**University of Illinois Urbana-Champaign
High Temperature Gas-cooled
Research Reactor:
Applicability of
Nuclear Regulatory Commission Regulations**

TOPICAL REPORT

**SUBJECT: UNIVERSITY OF ILLINOIS AT URBANA-CHAMPAIGN – SAFETY EVALUATION
FOR TOPICAL REPORT TITLED “HIGH-TEMPERATURE GAS-COOLED
RESEARCH REACTOR: APPLICABILITY OF NUCLEAR REGULATORY
COMMISSION REGULATIONS,” RELEASE 4 (EPID L-2022-NFN-0008)**

Figure 4-11. Draft NRC White Paper Logic Diagram for Non-LWR Regulation Applicability (Reference 17)

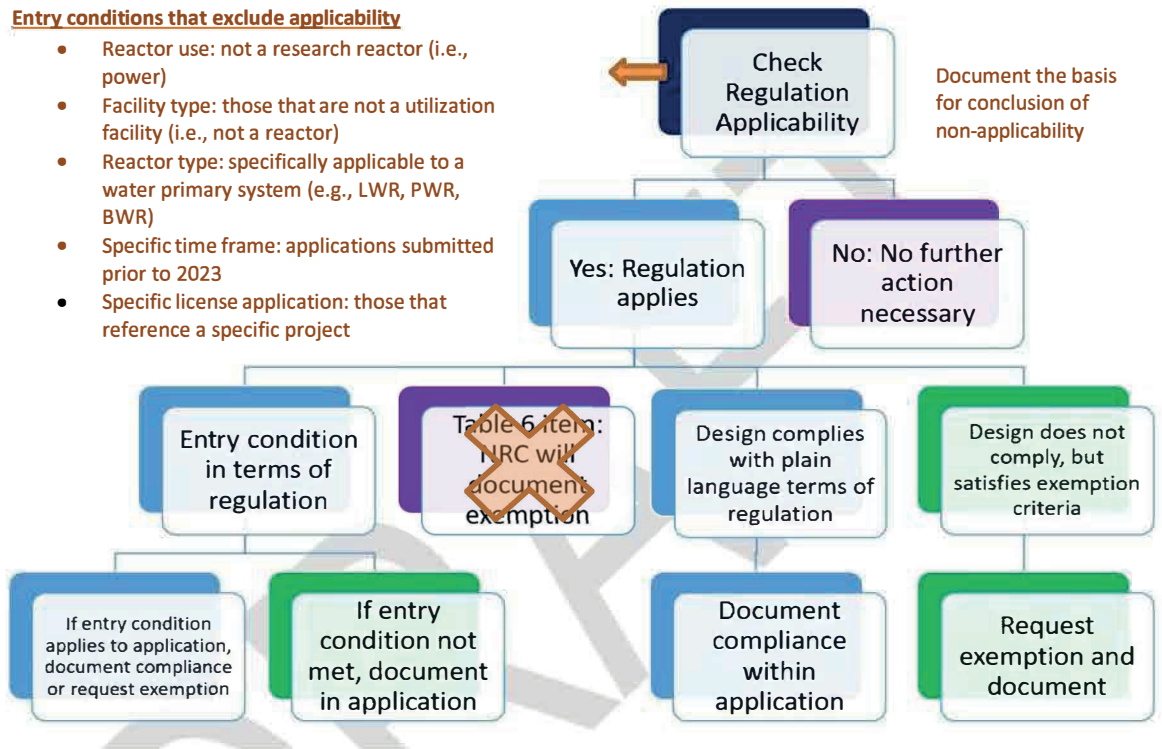
- 3) Figure 4-1, “Process for Determining Applicability of NRC Regulation,” indicates comparisons of determinations made using entry conditions would be made against other

documents as confirmatory actions, including comparisons against the list of regulations identified by the staff as applicable to research reactors in Appendix A to NUREG-1537, Part 1, "Guidelines for Preparing and Reviewing Applications for the Licensing of Non-Power Reactors - Format and Content," which was published in February 1996. Please clarify how regulations would be screened for changes implemented after the issue date of documents identified for use in comparisons to ensure validity of the comparisons.

RAI-3: *Figure 4-1, “Process for Determining Applicability of NRC Regulation,” indicates comparisons of determinations made using entry conditions would be made against other documents as confirmatory actions, including comparisons against the list of regulations identified by the staff as applicable to research reactors in Appendix A to NUREG-1537, Part 1, “Guidelines for Preparing and Reviewing Applications for the Licensing of Non-Power Reactors - Format and Content,” which was published in February 1996. Please clarify how regulations would be screened for changes implemented after the issue date of documents identified for use in comparisons to ensure validity of the comparisons.*

NRC provided a diagram of the process proposed in the draft white paper (repeated here as Figure 4-1) but annotated in orange with details of the UIUC MMR process. The entry condition screening is similar to the NRC’s process, with exclusion expanded to include entry conditions pertaining to power reactors.

The item with orange ✘ is not relevant because UIUC and USNC provide the exclusion and exemption justifications.
